## REFERRAL REPORT

Report Date: May 24, 2022  
Contact: Yardley McNeill  
Contact No.: 604.873.7582  
RTS No.: 14926  
VanRIMS No.: 08-2000-20  
Meeting Date: June 7, 2022

SUBJECT: CD-1 Rezoning: 5589-5661 Baillie Street

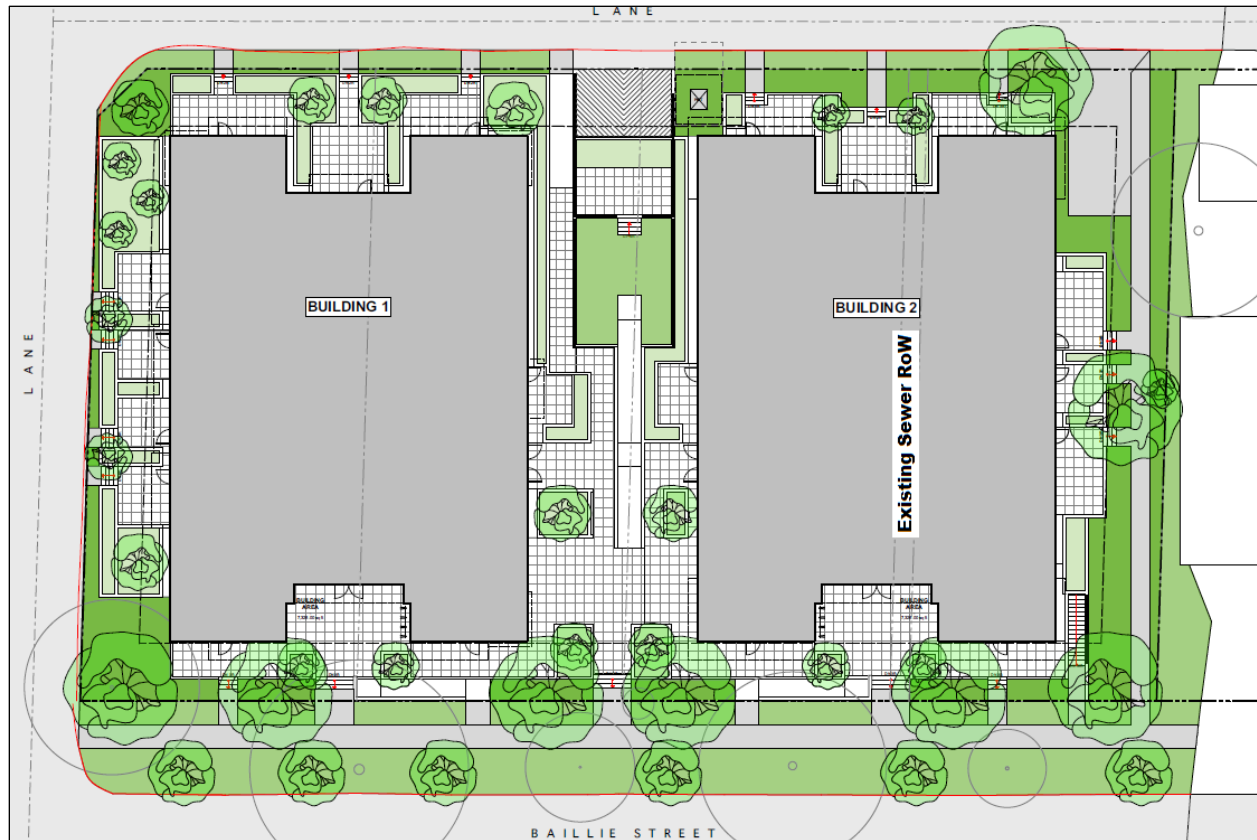
- Since this use is already approved in Cambie Corridor plan, why does this need rezoning? Site should be pre-zoned to save staff time and expense to the developer.

- Increasing the density of the project would yield higher levels of affordability.
- Given the site's context, the proposal's height and density seem conservative, and should be increased to deliver more affordable housing.

- The elevated play area may make units C1 and C2 feel dark and cramped. Balconies should be offset in order to provide privacy. Each building should have its own rooftop amenity, even if that requires a height relaxation.

- Ramps should be added to ensure accessibility for strollers and mobility devices.
- The proposed parking is excessive and could be reduced. Balconies should be offset in order to provide privacy.
